METROPOLITAN GOVERNMENT OF NASHVILLE AND DAVIDSON COUNTY

STAFF RECOMMENDATION
4107 Aberdeen Road
March 18, 2015

Application: New construction—infill and outbuilding
District: Cherokee Park Neighborhood Conservation Zoning Overlay
Council District: 24
Map and Parcel Number: 10312011200
Applicant: Stewart Bronson, Stone Oak Builders
Project Lead: Melissa Baldock, melissa.baldock@nashville.gov

FRONT ELEVATION
1/8" = 1'-0"

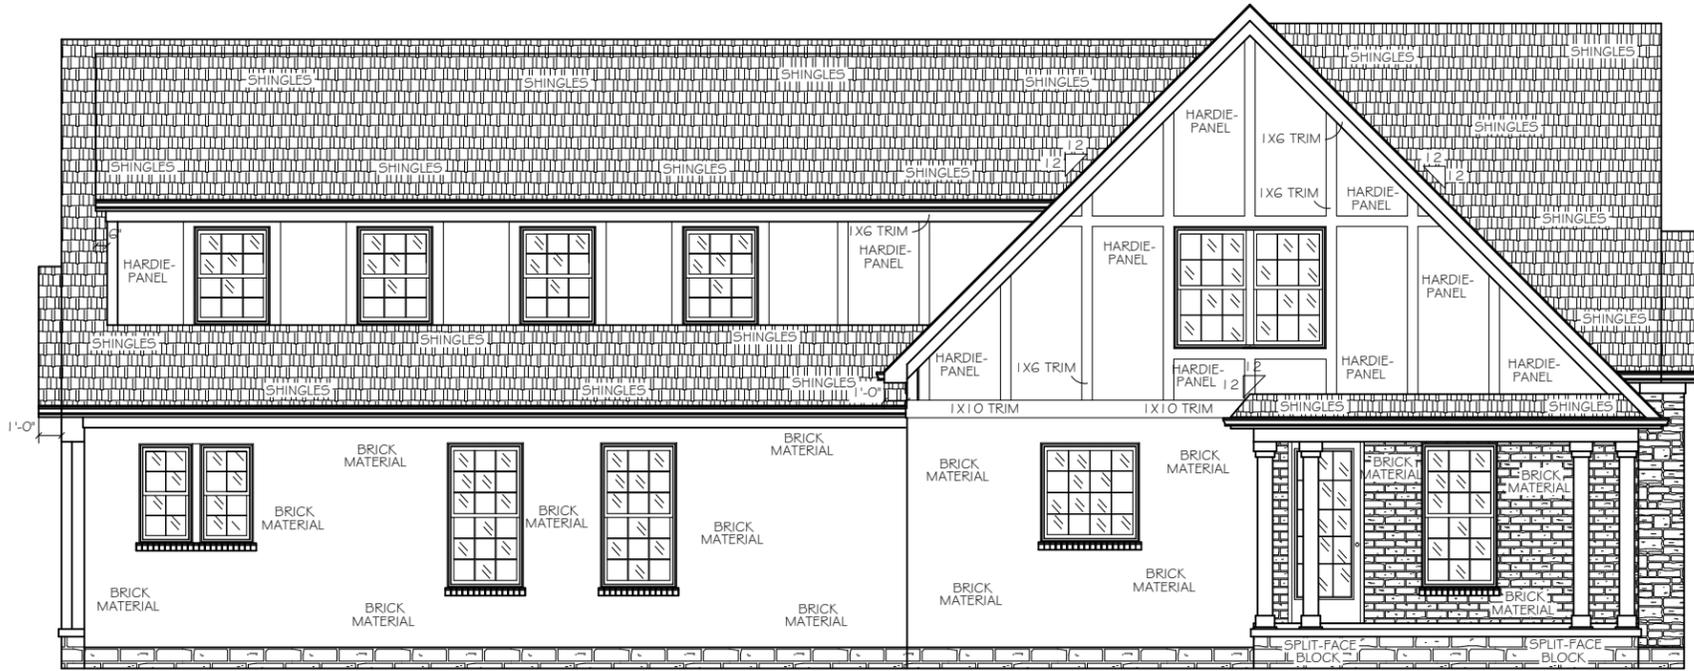
Height & Scale: The proposed infill is one-and-a-half stories in height, which is similar to the other historic houses on this part of Aberdeen Road. It has an eave height of approximately eleven feet (11') above grade, and a ridge height of twenty-nine feet (29'). Staff finds that this height meets the context where the historic houses range in height from about twenty feet (20') to thirty-two feet (32'), with most houses being about twenty-four to twenty-eight feet (24' – 28') tall. The foundation height is shown as two feet (2'), and staff asks to verify in the field that the foundation height is compatible with the foundation heights of nearby historic structures.

Materials: The primary cladding material for the infill will be brick. Stone will be used as an accent material around the doorway. Staff asks to review a brick and stone sample. Hardie panel and battens will be used in the gable and dormer fields. The trim will be wood or cement fiberboard, the foundation will be split face concrete block, and the roof will be asphalt shingles. The materials for the windows and doors were not specified, and staff asks to approve the window and door specifications. Likewise, the materials of the front stoop steps and stoop floor were not noted, and staff asks to approve these materials. With the aforementioned staff approvals, staff finds that the infill meets Section II.B.1.d. of the design guidelines.

Roof form: The primary roof form is a cross gable. The front facing gables have a slope of 14/12, while the side gable has a slope of 12/12. The front dormer is set back two feet (2') from the wall below and has a shed roof with a slope of 6/12. With this condition, staff finds that the project meets Section II.B.1.e. of the design guidelines.

Proportion and Rhythm of Openings: The windows on the proposed infill are generally twice as tall as they are wide, thereby meeting the historic proportions of openings. There are no large expanses of wall space without a window or door opening. The front dormer windows do not appear to have four to six inch (4"-6") mullions in between them, and staff asks that they include the four to six inch (4"-6") mullions. Staff finds the project's proportion and rhythm of openings to meet Section II.B.1.g. of the design guidelines.

1. The finished floor height be consistent with the finished floor heights of the neighboring historic houses, to be verified by MHZC staff in the field;
2. The front dormer windows have a four to six inch (4"-6") mullion in between them;
3. Staff approve the final details, dimensions and materials of windows and doors prior to purchase and installation;
4. Staff approve the roof color, brick and stone samples, and the stoop steps and floor; and
5. The HVAC shall be located behind the house or on either side, beyond the mid-point of the house.

LEFT ELEVATION
1/8" = 1'-0"

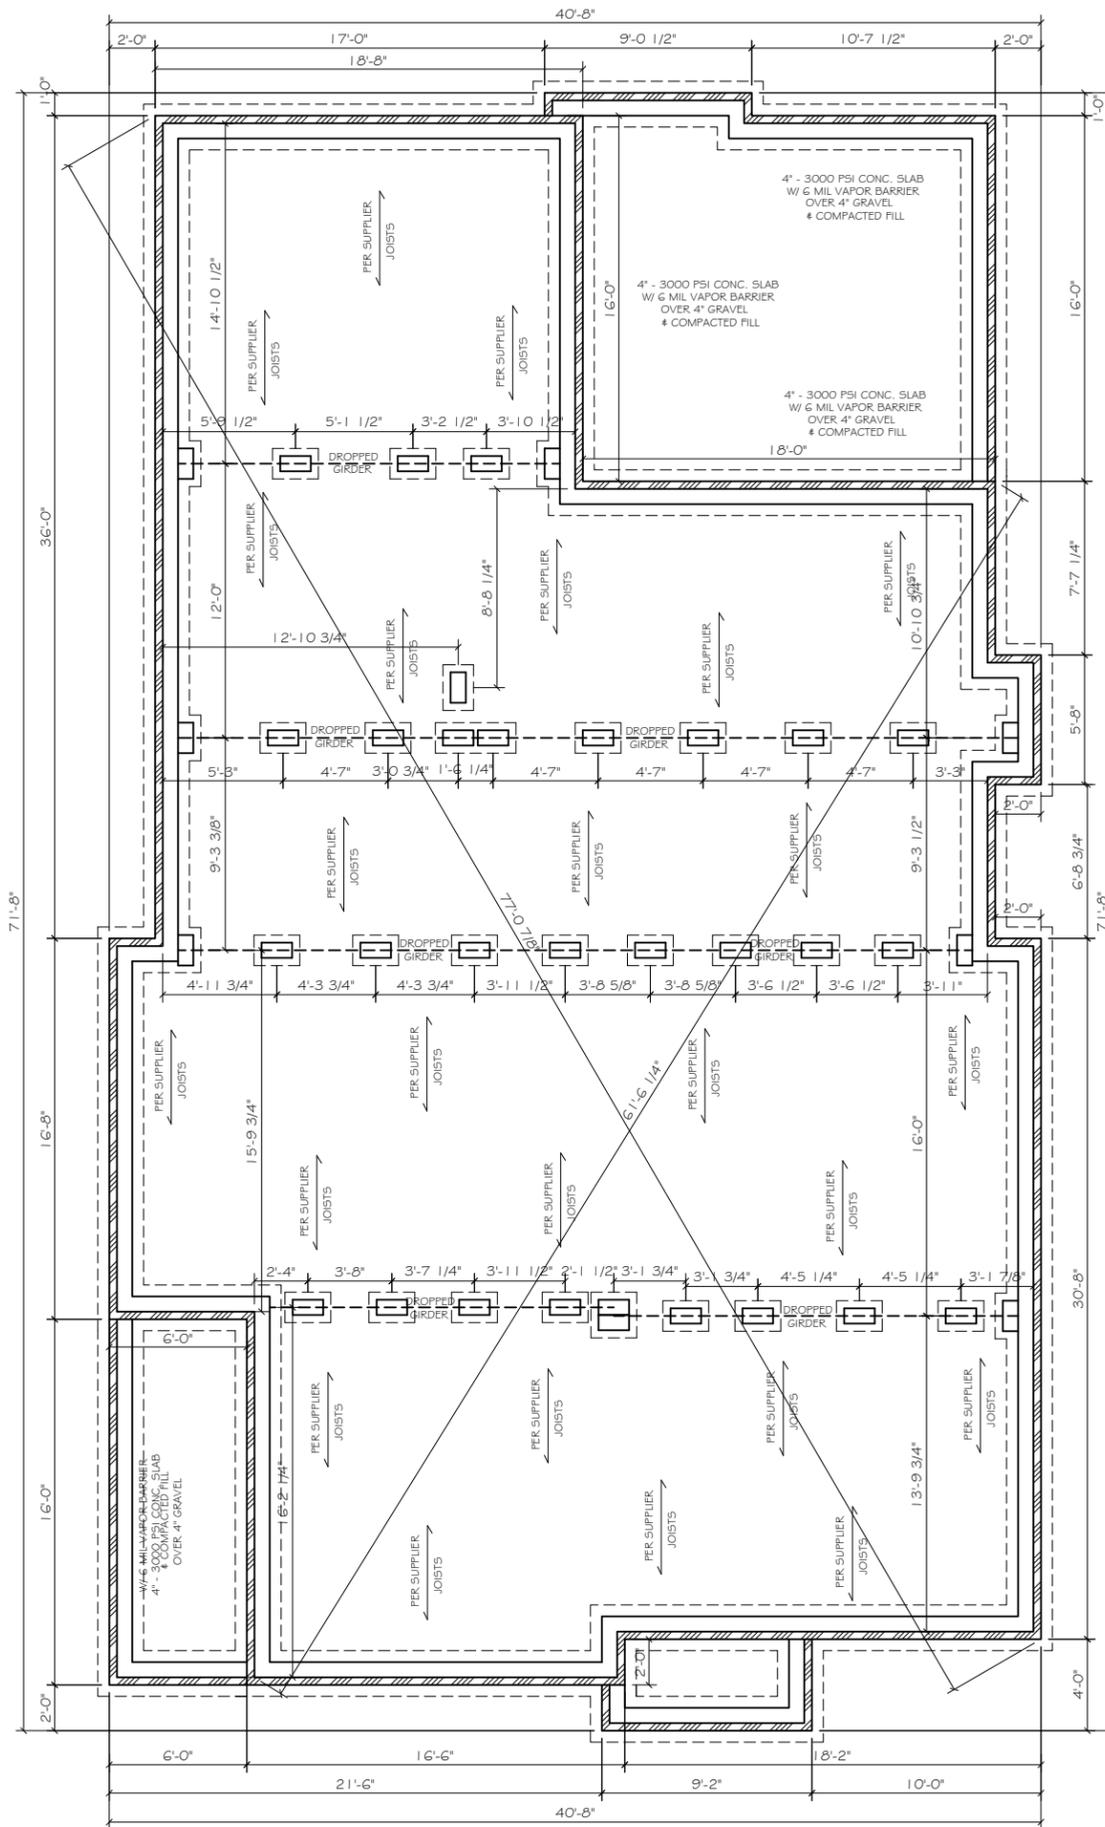
Orientation: The infill is oriented to face Aberdeen Road, which is appropriate. It has a stoop entryway that is four feet (4') deep. Staff finds that this depth is appropriate for a stoop. A covered side porch is located at the front east side of the house. The side porch is six feet (6') wide and sixteen feet (16') deep. Access to the porch is from the east side elevation, and it will not serve as the primary entrance to the house. Vehicular access to the site will be from an existing driveway to the east of the house. Staff finds that the project's orientation meets Section II.B.1.f. of the design guidelines.

Appurtenances & Utilities: No changes to the site's appurtenances were indicated on the drawings. The location of the HVAC and other utilities was also not noted. Staff asks that the HVAC be located on the rear façade, or on a side façade beyond the midpoint of the house.

FRONT ELEVATION

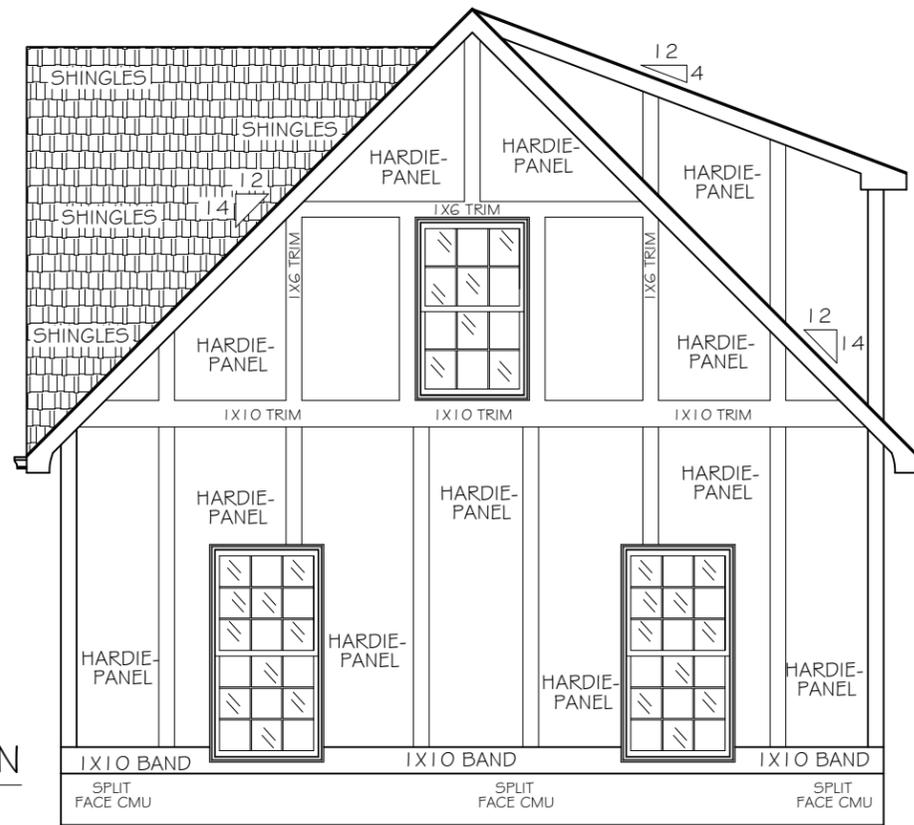
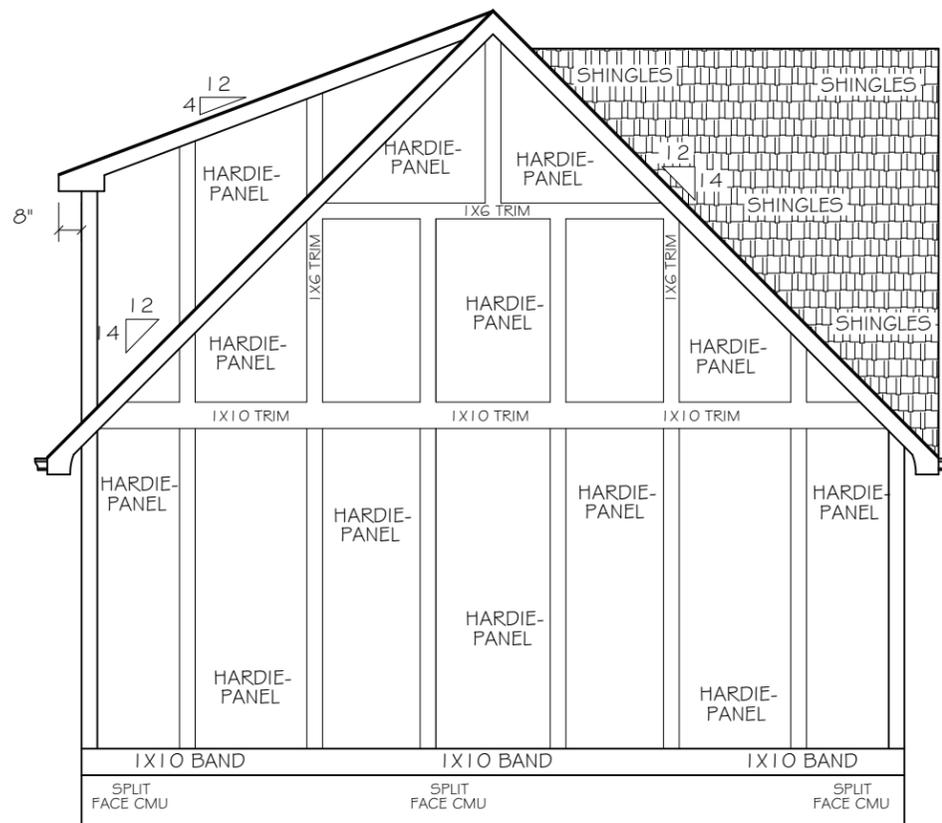
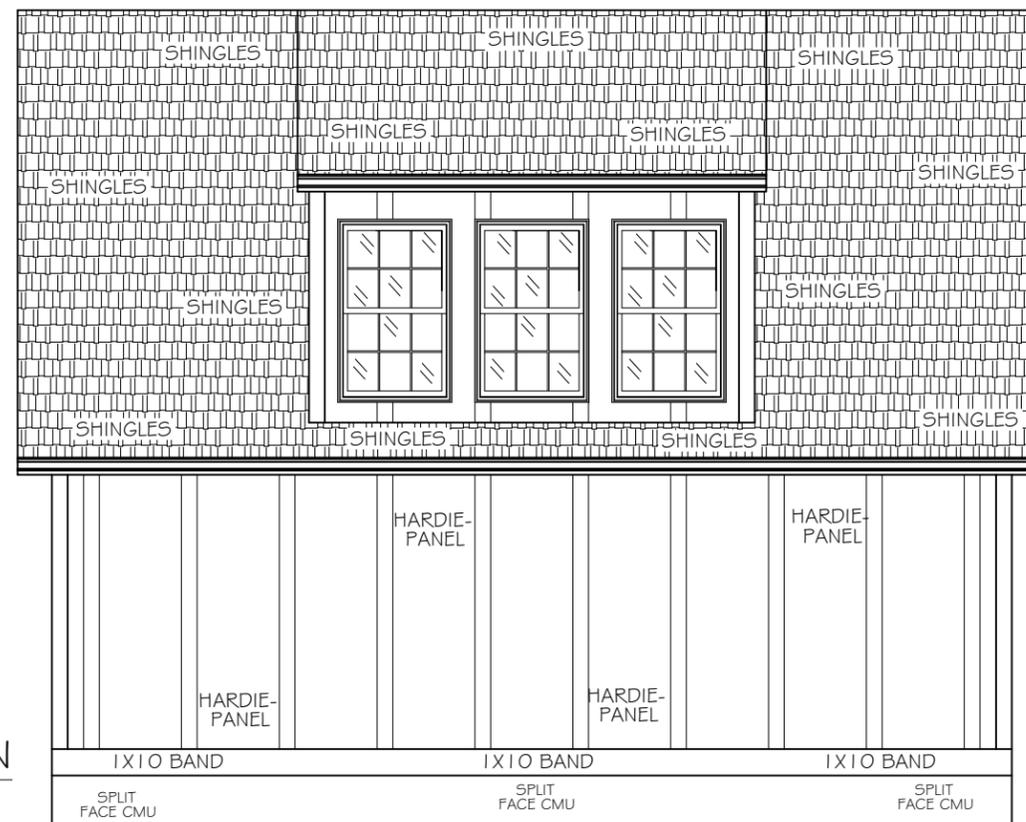
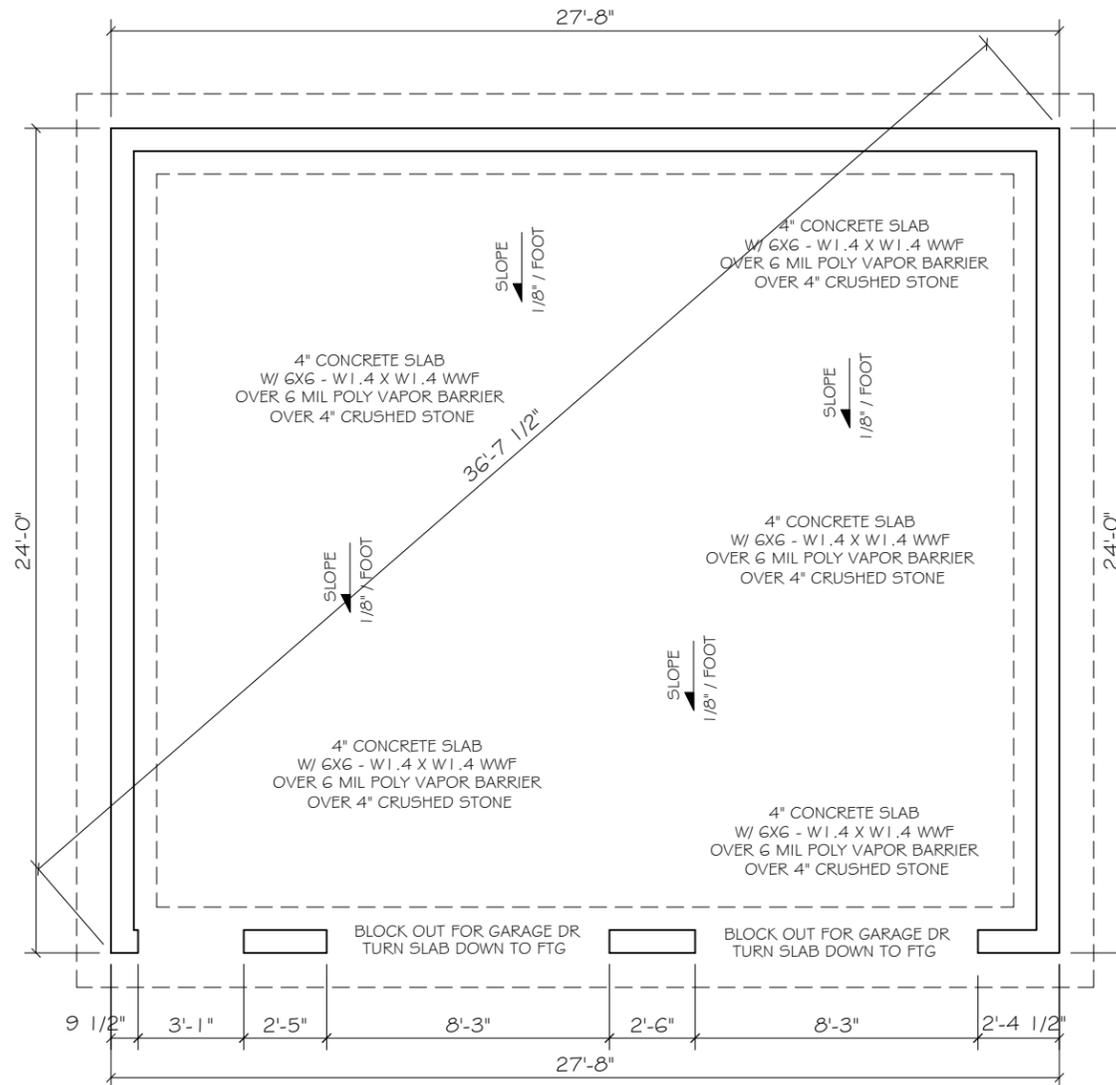
appropriateness of the proposed outbuilding. Staff notes that while the rear dormer is 50% of the roof scape, it does not set back two feet (2') from the wall below. Staff finds this to be acceptable in this instance because the dormer is located on the rear and because the outbuilding will not be used as a detached accessory dwelling unit. Staff find that the outbuilding meets section II.B.1.h of the design guidelines.

Existing conditions (height of historic portion of the home to be measured from finished floor)	Potential maximums (heights to be measured from grade)	Proposed (should be the same or less than the lesser number to the right)
Ridge Height	29'	25'	23'9"
Eave Height	11'	1 story 10' or 2 story 17'	10'
